Access Compliance Report

Public Rights-of-Way

(Curb Ramps)

Intersection ID: 26932	Main Street: CARLESBROOKE_TR	Cross Street: WYNYATES_LN	Location: NE
ADA ID: 6404599184E6	Ramp Type: Perp	Initial Pass/Fail: Fail	Overall Compliance: No
Severity Score: 22.5			
Codes/Mitigation Info/Possible Solution		Field Measurements/Component Compliance

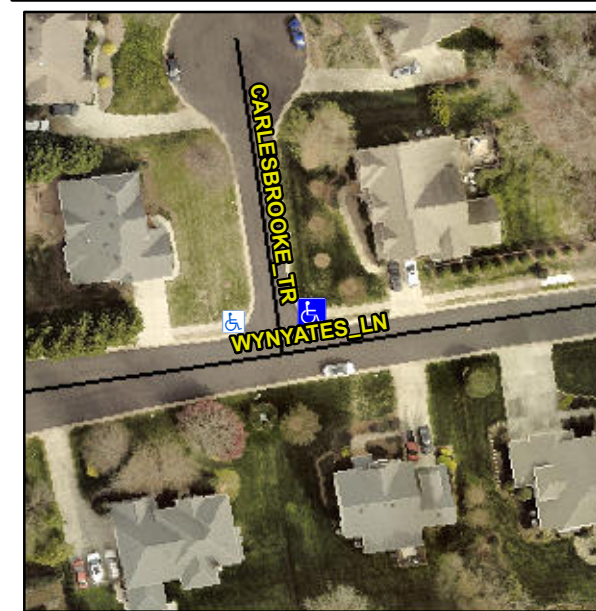
R304.5.1, R304.2.2, R304.5.3

Compliance	Description	Data	Compliance	Description	Data
N/A	Ramp Length (in)	35.0	No	Ramp Slope (%)	8.8
No	Ramp Width (in)	41.0	No	Ramp XSlope (%)	4.1
N/A	Flare Type LT	N/A	N/A	Flare Type RT	N/A
N/A	Flare Slope LT (%)	N/A	N/A	Flare Slope RT (%)	N/A
N/A	Flare Traversable LT?	N/A	N/A	Flare Traversable RT?	N/A
N/A	Landing Length (in)	N/A	N/A	DWS Provided?	N/A
N/A	Landing Width (in)	N/A	N/A	DWS Contrast?	N/A
N/A	Landing Slope (%)	N/A	N/A	DWS Length (in)	N/A
N/A	Landing X Slope (%)	N/A	N/A	DWS Full Width?	N/A
N/A	Landing Curb? (Y/N)	N/A	N/A	DWS Offset (in)	N/A
N/A	Shared Landing?	N/A			
N/A	Gutter Ponding?	N/A	N/A	Gutter Slope (%)	N/A
N/A	Gutter Lip Ht (in)	N/A	N/A	Gutter X Slope (%)	N/A
N/A	Painted X Walk1?	No	N/A	Painted X Walk2?	N/A
	X Walk 1 Direction	To W		X Walk 2 Direction	N/A
N/A	X Walk 1 Width (in)	N/A	N/A	X Walk 2 Width (in)	N/A
	X Walk 1 Slope (%)	7.2		X Walk 2 Slope (%)	N/A
	X Walk 1 X Slope (%)	1.4		X Walk 2 X Slope (%)	N/A

Remove & Replace Entire Ramp.
